Notice No.1

Rules and Regulations for the
Classification of Ships, July 2017

Issue date: September 2017

Figure 13.8.1 Windlass loading

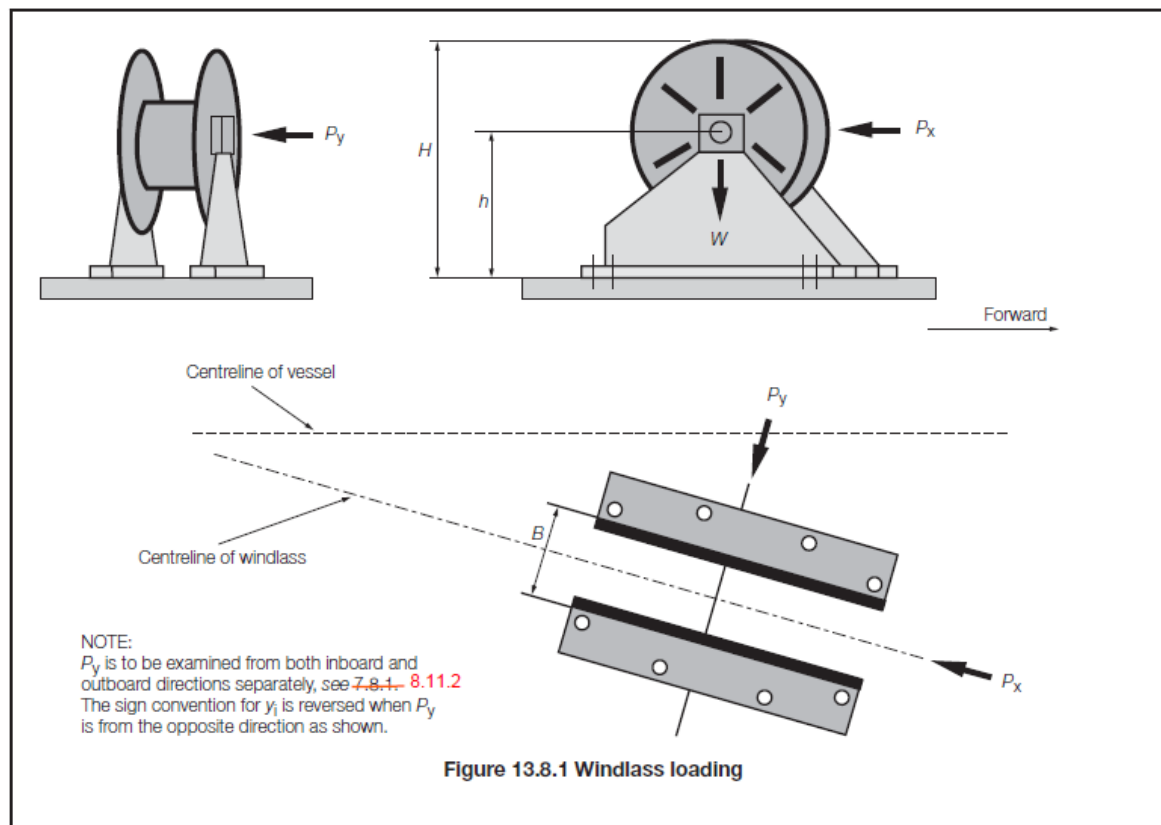
NOTE:
P_y is to be examined from both inboard and
outboard directions separately, see ~~7.8.1.~~ 8.11.2
The sign convention for y_i is reversed when P_y
is from the opposite direction as shown.
